Entergy Nuclear Operations, Inc.  
Palisades Nuclear Plant  
27780 Blue Star Memorial Highway  
Covert, MI 49043-9530  
Tel 269 764 2000

PNP 2014-010

SUBJECT: Palisades Nuclear Plant Second Six-Month Status Report in Response to March 12, 2012 Commission Order Modifying Licenses with Regard to Reliable Spent Fuel Pool Instrumentation (Order Number EA-12-051)

# **Palisades Nuclear Plant Second Six-Month Status Report in Response to March 12, 2012 Commission Order Modifying Licenses with Regard to Reliable Spent Fuel Pool Instrumentation (Order Number EA-12-051)**

Figure 1: SFP Area Plan View

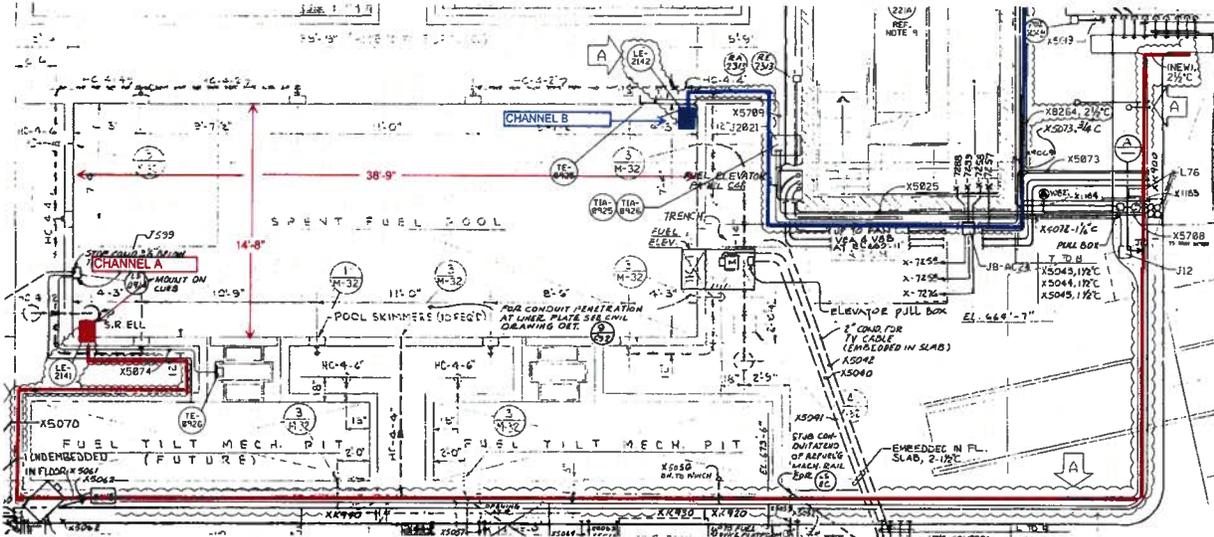
Attachment 1 of the Overall Integrated Plan (Reference 1) shows Channel A mounted against the north wall near the northwest corner of the Spent Fuel Pool (SFP). The location of Channel A has been moved to the west wall near the northwest corner of the SFP. See Section 7 for additional discussion. Section 7 also contains a figure with the new cable routing for the SFP area.

Section 3.4 of the Interim Staff Evaluation discusses the arrangement of the SFPI channels and references the sketch in Attachment 1 of the Overall Integrated Plan. As discussed in Section 4, the location of the Channel A level instrument has been moved to the west SFP wall, within 12" of the northwest SFP corner. The updated sketch of the SFPI arrangement showing the new cable routing is provided below in Figure 1.

Section 3.4 of the Interim Staff Evaluation also refers to a statement that declares cables in the SFP area will be routed in seismically mounted rigid metal conduit. It should be noted that this statement does not apply to the first 20 ft. of cable run, which is comprised of SiO<sub>2</sub> stainless steel armored cable. The SiO<sub>2</sub> stainless steel armored cable then transitions to coaxial cable, at which point the coaxial cable will be installed in seismically mounted rigid metal conduit for the remainder of the run in the SFP area. This cable installation is applicable to both Channel A and Channel B.
